Modification Summary

GCRP 13 - Thursday 9th February 2006

Figure WFPS1.3

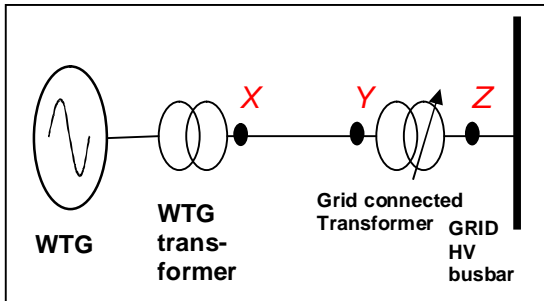
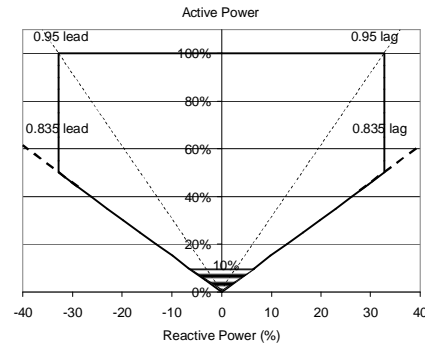
In order to avoid any confusion as to which is the reference voltage it is proposed to change the current clause *from*:

“**Wind Farm Power Stations** shall be capable of operating at any point within the **Power Factor** ranges illustrated in Figure WFPS1.4, as measured at the LV side of the **Grid Connected Transformer** (point Y in Figure WFPS1.3), for any **Voltage** at the **Connection Point** within the ranges specified in WFPS1.6.1”

Wind Farm Power Stations shall be capable of operating at any point within the **Power Factor** ranges illustrated in Figure WFPS1.4, as measured at the LV side of the **Grid Connected Transformer** (point Y in Figure WFPS1.3).

The design reference **Voltage** for the reactive power capability shall be the nominal **Voltage** at point Y.

The **Grid Connected Transformer** tap changing range must be capable of ensuring nominal **Voltage** at point Y for any **Voltage** at the **Connection Point** (Point Z) within the ranges specified in WFPS1.6.1.

Clause WFPS1.4.1 Fault Ride Through Requirements currently states

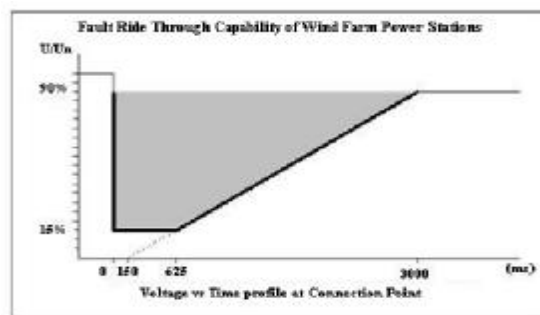
WFPS1.4.1 A Wind Farm Power Station shall remain connected to the **Transmission System** for **Transmission System Voltage** dips on any or all phases, where the **Transmission System Voltage** measured at the HV terminals of the **Grid Connected Transformer** remains above the heavy black line in *Figure WFPS1.1*.

In a phase-phase fault, $V_{\text{LINE} - \text{LINE}} = 0$ while $V_{\text{PH}} \sim 0.5$ p.u. It then could be up to interpretation whether the voltage refers to the line voltage or the phase voltage.

To avoid any confusion that may arise for a phase to phase fault it is proposed to add the word **Phase** as shown underlined in the revised clause below and also add “**Phase**” before the word “**Voltage**” on the diagram in Figure WFPS1.1.

WFPS1.4.1 A Wind Farm Power Station shall remain connected to the **Transmission System** for **Transmission System Voltage** dips on any or all phases, where the **Transmission System Phase Voltage** measured at the HV terminals of the **Grid Connected Transformer** remains above the heavy black line in *Figure WFPS1.1*.

“Phase Voltage: Voltage measured between the line and system neutral”.
